September 2017
FL724A-Q
NHTSA #16V-666 (Non-School Buses)
NHTSA #16V-664 (School Buses)
THIRD REVISED NOTICE

Subject: ICU3S Instrument Cluster Hydraulic Brake Telltale

Models Affected: Specific Freightliner Business Class M2 vehicles and Freightliner Custom Chassis S2 bus and B2 (Thomas Built Buses C2 Saf-T-Liner) school bus chassis manufactured March 3, 2015, through September 8, 2016.

Fig. 1, A "Park" Telltale - Replace ICU3S

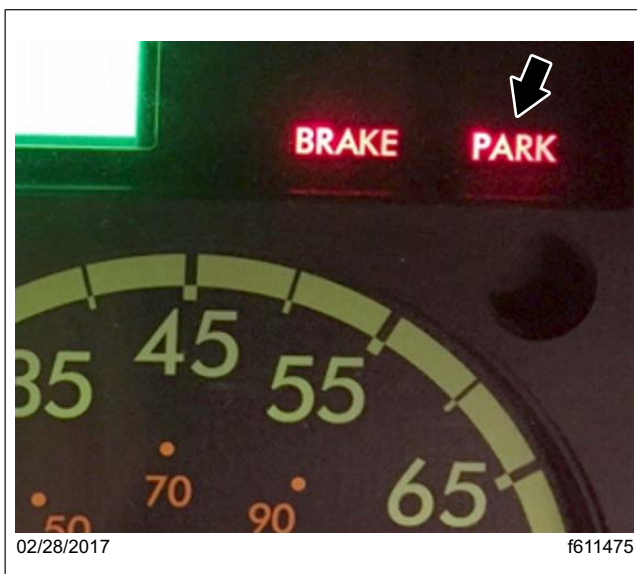
1. Check the base label (Form WAR259) for a completion sticker for FL724 (Form WAR260) indicating this work has been completed. The base label is usually located on the passenger-side door, about 12 inches (30 cm) below the door latch (trucks) or over the driver's window (buses). If a completion sticker is present, no work is needed. If a completion sticker is not present, proceed to the next step.
2. Park the vehicle, shut down the engine, and apply the parking brakes. Chock tires.
3. During the bulb check at key-on, inspect the telltales on the ICU3S (affected telltales will be illuminated for three seconds). See [Fig. 1](#) and [Fig. 2](#).

If the ICU3S has a "Park" telltale, continue with the next step.

If the ICU3S has a "Brake" telltale, no further work is needed. Clean a spot on the base label (Form WAR259), write the recall number, FL724, on a red completion sticker (Form WAR260), and attach it to the base label.
